ADDENDUM #1
INVITATION FOR BID #22-33

POLICE HEADQUARTERS HVAC SYSTEM IMPROVEMENTS

THIS ADDENDUM IS TO: ANSWER THE QUESTIONS BELOW AND TO PROVIDE AMENDED PROJECT DRAWINGS, ATTACHED:

1 SECOND FLOOR HVAC NEW WORK PLAN
SCALE: 1/4" = 1'-0"

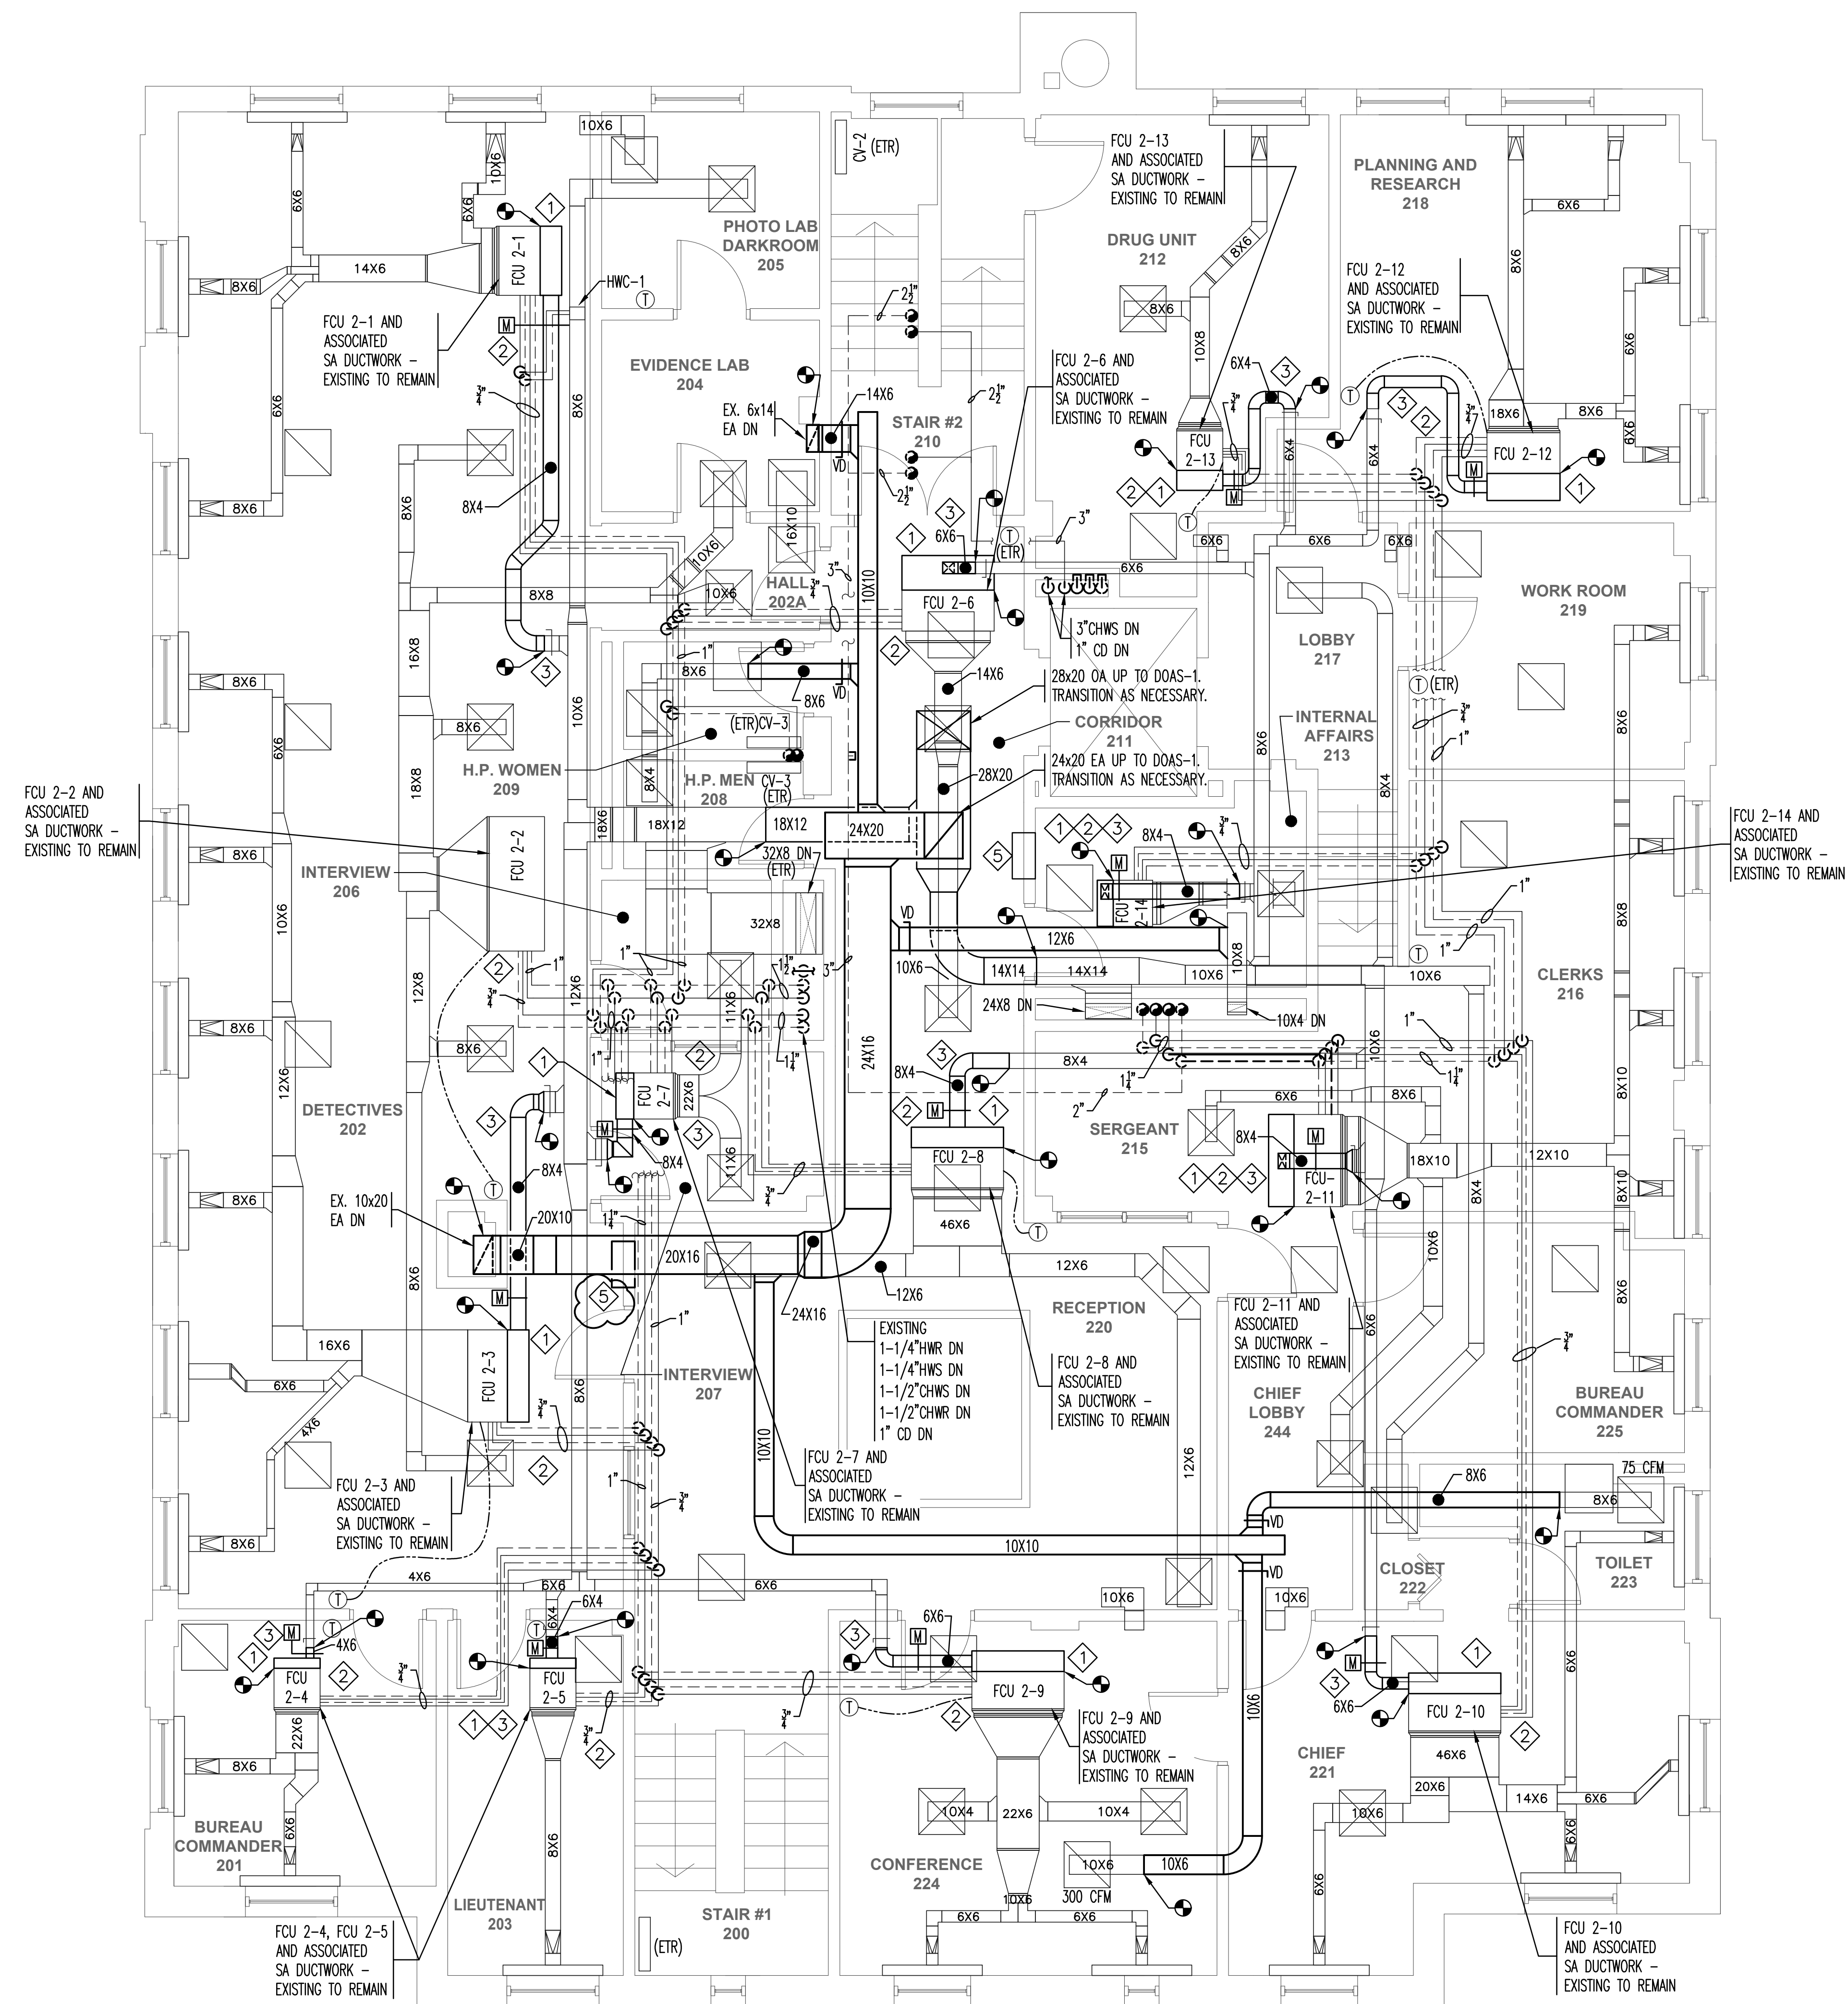
Q8. Please indicate on Drawing M-2.2 where the refrigeration and condensate piping at AC-1-5 is to be routed and terminated. Please indicate on Drawing M-2.2 where the condensate piping for AC-1-1, AC-1-2, AC-1-3 and AC-1-4 is to be routed and terminated.

Q11. Please indicate on Drawing M-2.2 where the condensate piping for FCU-1-8, 9, 10, 11 and 12 is to be routed and terminated.

Drawing M-2.2: Removed the reference of the adding the control panel under Alt #1, and added the condensate drain piping and refrigerant lines between the chase and the new units.

A8. There is existing 1-1/4" condensate drain piping that traverses Rooms 117 and 119, where it turns and goes down to the basement level via the existing chase. M-2.2 has been updated to show the routing of the all the refrigerant piping. The 1-1/4" Condensate Drain Piping is now shown. The replacement fan coil units should reuse the existing condensate drain piping, and all new equipment has been connected to the appropriate piping system.

A11. The drawings have been updated to show that there is existing 1-1/4" condensate drain pipe that is connected to the existing fan coil units that are coming out. Connect the replacement FCUs (1-8,1-9,1-10, and 1-11) to the original condensate drain piping. FCU 1-12 is a new unit and M-2.2 has been updated to show the connection into the existing drainage piping.

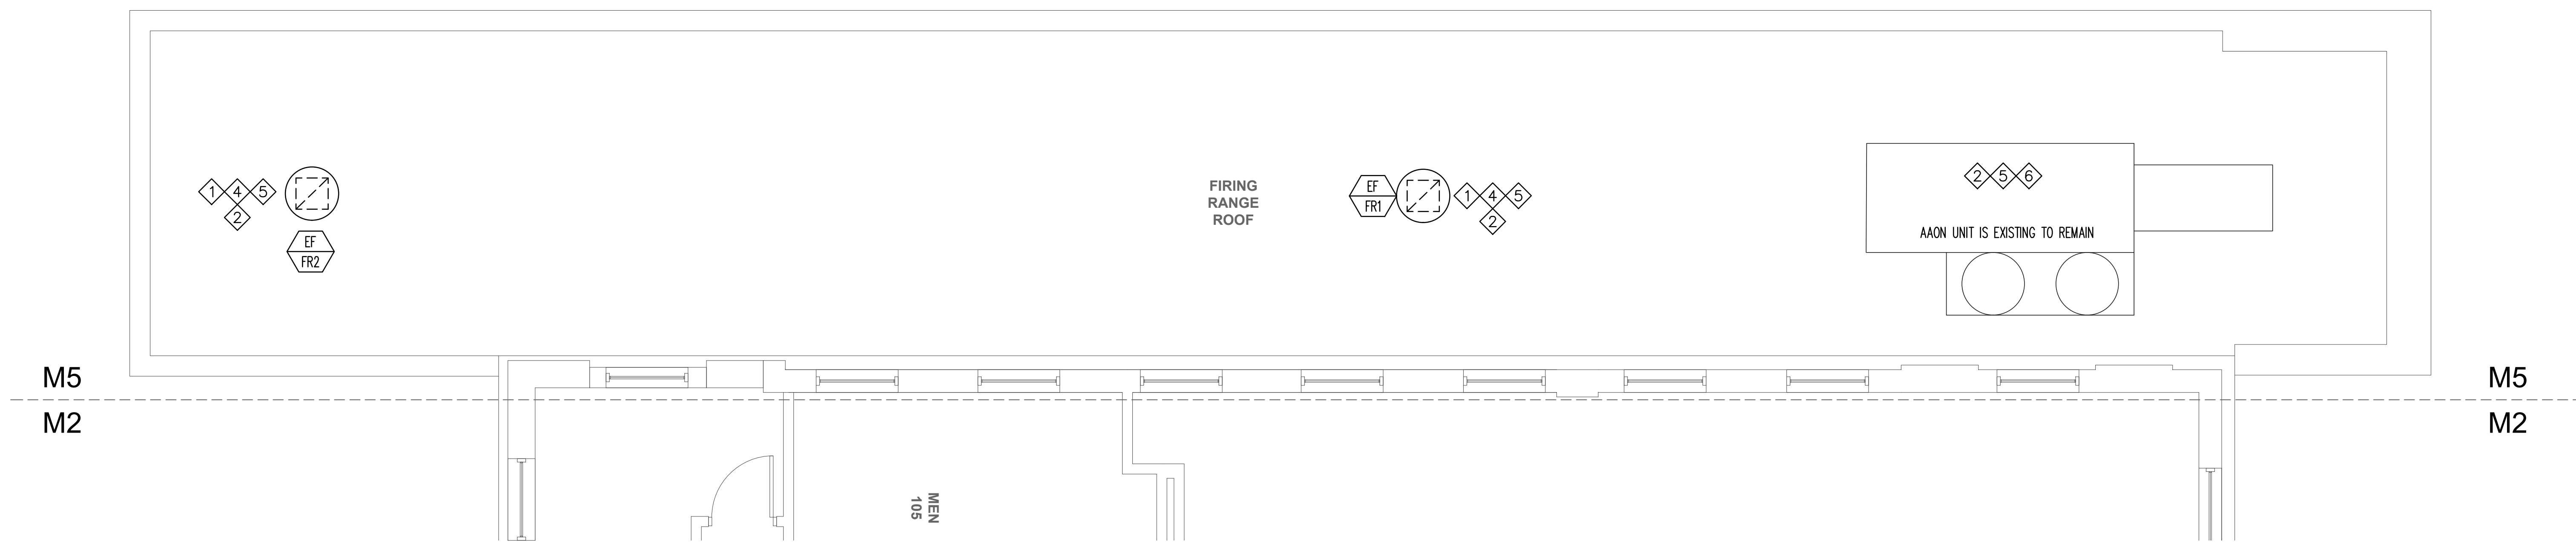
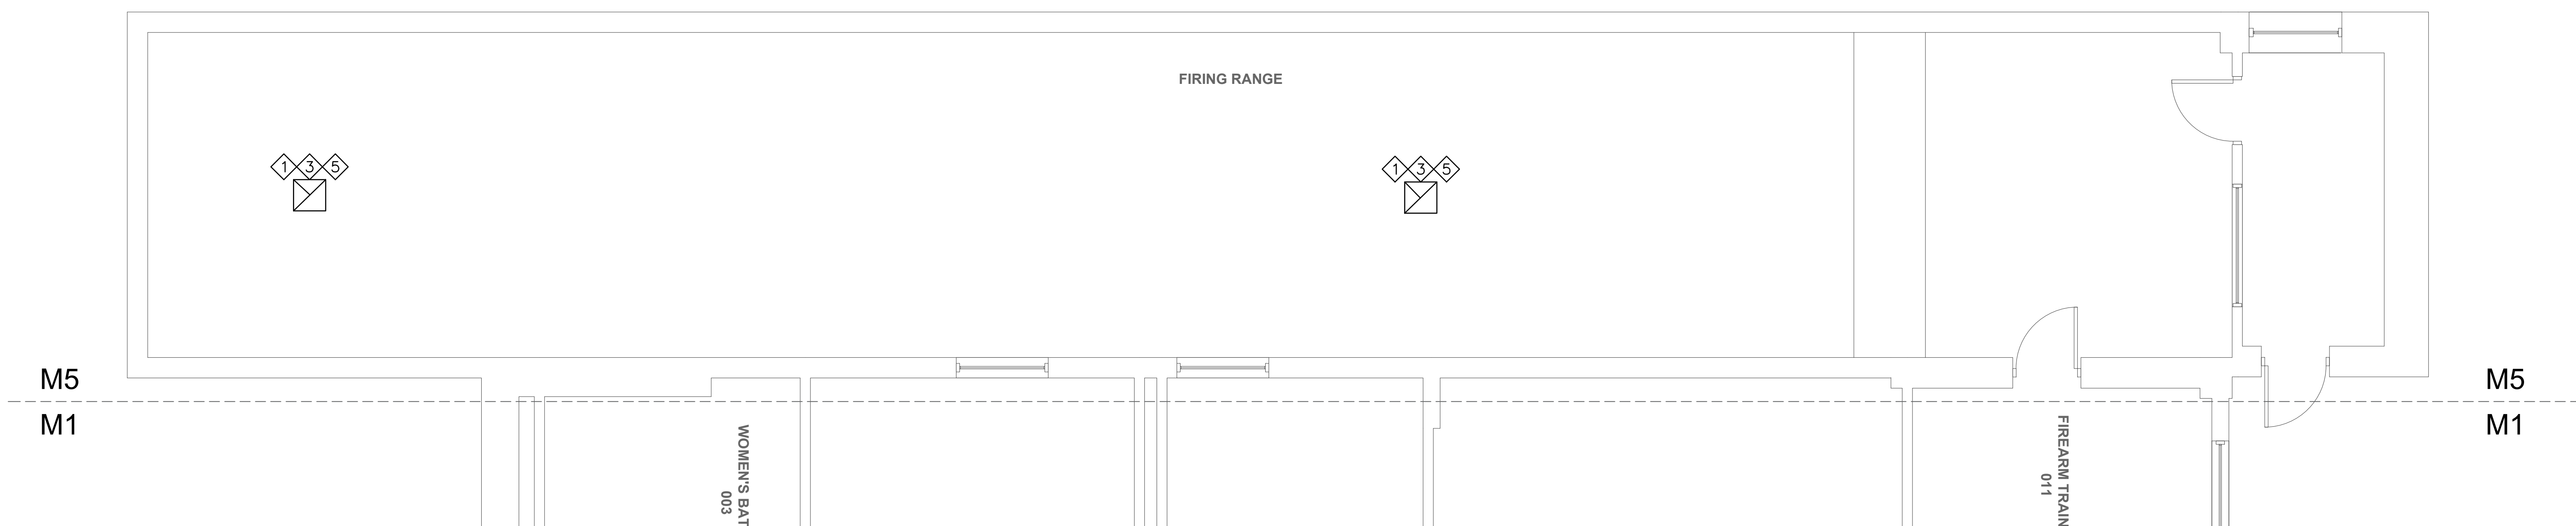
Drawing M-5: Fixed the reference for the fan detail to point to M-8.1 instead of M-5.

- ◇ ADD A NEW THERMOSTAT ON THE INSIDE FACE OF THE EXHAUST AIR DUCTWORK AS SHOWN IN THE EXHAUST FAN DETAIL ON PAGE M-8.1.
- ◇ ALL NEW CURB ADAPTOR/EXTENSIONS AND FILTER BOXES SHALL BE INSULATED TO A R-VALUE OF 25. SEAL THE EXISTING CURB TO THE INTERNAL STRUCTURE AIR TIGHT. FILTER BOX SHALL BE CAMEL MAGNA/PACK OR EQUAL.
